# HISTORIC AND DESIGN REVIEW COMMISSION

**HDRC CASE NO:** 2022-260  
**ADDRESS:** 255, 259 BRAHAN BLVD; 211, 215 HAYWOOD  
**LEGAL DESCRIPTION:** NCB 3856 (255 BRAHAN {AMENDING}), BLOCK 2 LOT 26 & 27  
**ZONING:** RM-4, H  
**CITY COUNCIL DIST.:** 2  
**DISTRICT:** Westfort Historic District  
**APPLICANT:** Jose Calzada  
**OWNER:** SUN DEVELOPMENT SERVICES LLC  
**TYPE OF WORK:** Revisions to a previously approved design regarding building setbacks  
**APPLICATION RECEIVED:** April 21, 2022  
**60-DAY REVIEW:** Not applicable due to City Council Emergency Orders  
**CASE MANAGER:** Edward Hall

## REQUEST:

CONCEPTUAL SITE PLAN

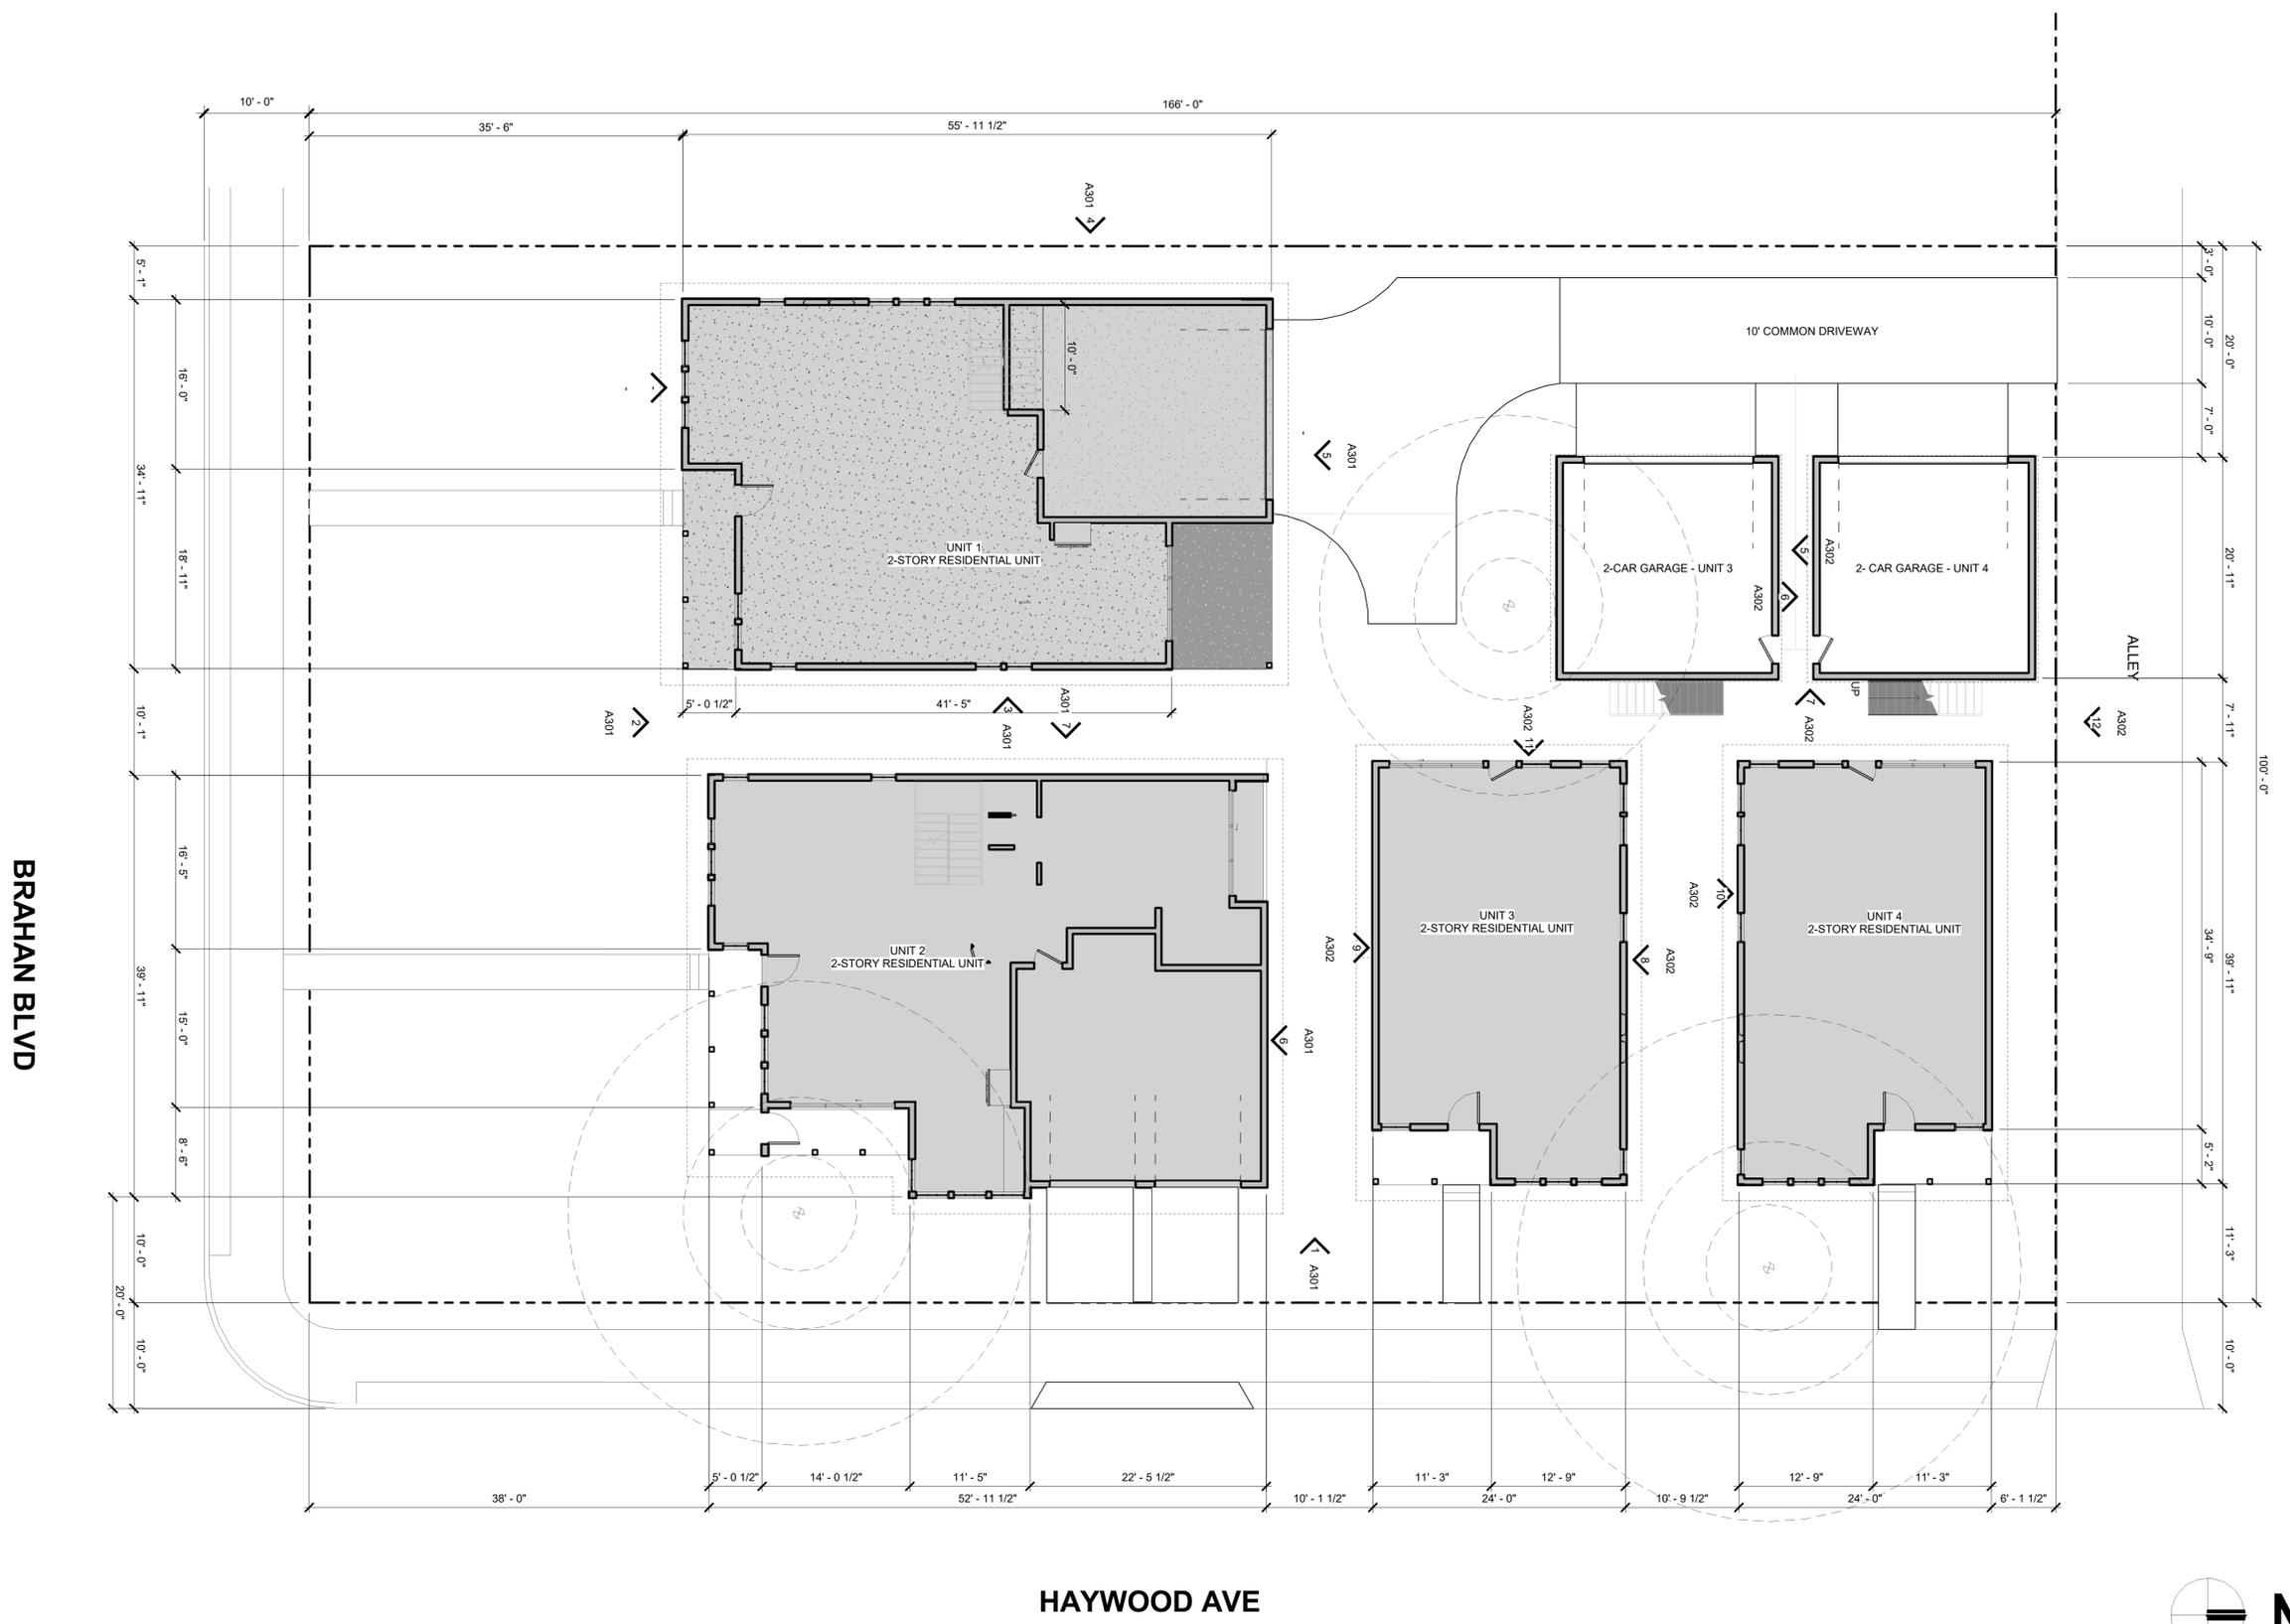
- iv. That a detailed landscaping plan be submitted to OHP staff for review and approval.
- c. **FRONT SETBACK MODIFICATIONS** – The applicant has proposed to amend the previously approved setbacks as follows:

- Unit C/3 – reduction in setback from Haywood Avenue from 11' – 3" to 10' – 0".
  - Unit C/4 – A reduction in setback from Haywood Avenue from 11' – 3" to 10' – 0".

Previously, the applicant noted that each setback for proposed new construction on Haywood Avenue would feature a setback that is greater than the front setbacks found historically on site. Staff finds that a modification

in front setback for the proposed new construction may be appropriate provided that the front setbacks remain greater than the side setback of the historic structure addressed as 262 Army.

b. REAR/WEST SETBACK MODIFICATIONS – The applicant has proposed to amend the previously approved setbacks as follows:

- Garage Unit C/3 – A decrease in rear setback from 20' to 18'.
- Garage Unit C/4 – A decrease in rear setback from 20' to 18'.

Generally, staff finds the proposed modified rear setback for the two garage units to be appropriate.

d. BUILDING SPACING MODIFICATIONS – The applicant has proposed to amend the previously approved building spacing as follows:

- Garage Unit C/3 and Unit C/4 – An increase in separation from 7' – 11" to 10' – 0".
- Garage Unit C/4 and Unit C/4 – An increase in separation from 7' – 11" to 10' – 0".

Generally, staff finds the proposed increase in building spacing to be appropriate.

Staff recommends approval of the proposed modifications to the previously approved setbacks and building spacing based on findings a through d with the following stipulations:

- i. That the front setbacks of Units C/3 and C/4 remain greater than the side setback of the primary historic structure addressed as 262 Army.
- ii. That all other stipulations of approval, as noted in finding b, are followed.
